Service Bulletin

PRELIMINARY INFORMATION

Subject: Pop Noise From Fuel Tank After a Cold Start or EVAP Purge Event

Models: 2010 -2017 Chevrolet Equinox
2010-2017 GMC Terrain

1. Flange location of the auxiliary fuel module (Fuel Pump Auxiliary)
2. Primary Pump NOT the correct component to replace (Fuel Pump)

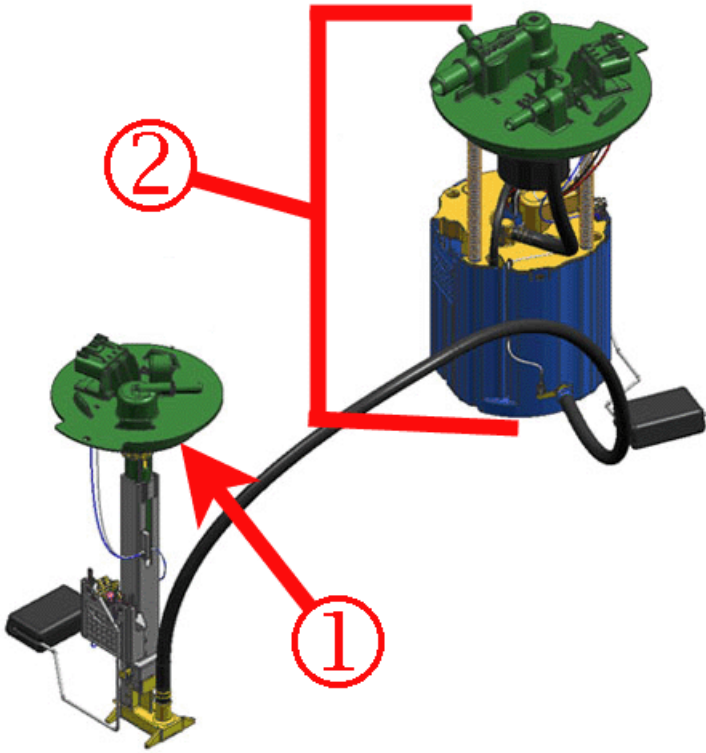
The cause for this concern is the auxiliary fuel pump in the left side of the fuel tank changing height (spring loaded leg).

The part number on the box of the auxiliary fuel pump has not changed but the auxiliary fuel pump inside of the box has.

Important: The condition described in this PI applies only to the auxiliary fuel pump module assembly. The Parts Catalog calls this auxiliary pump component the "Fuel Pump Auxiliary" which is the correct part for this repair. Replacing the primary fuel pump module assembly would NOT correct this noise condition. The parts catalog calls this primary pump component the "Fuel Pump" which is the incorrect part for this repair.

After ordering the auxiliary fuel pump, remove it from the box and verify the letters "PPA" are cast into the top of the fuel pump flange.

This is the revised auxiliary fuel pump designed to correct the pop/popping noise. The original auxiliary fuel pump has "POM" cast into the flange.
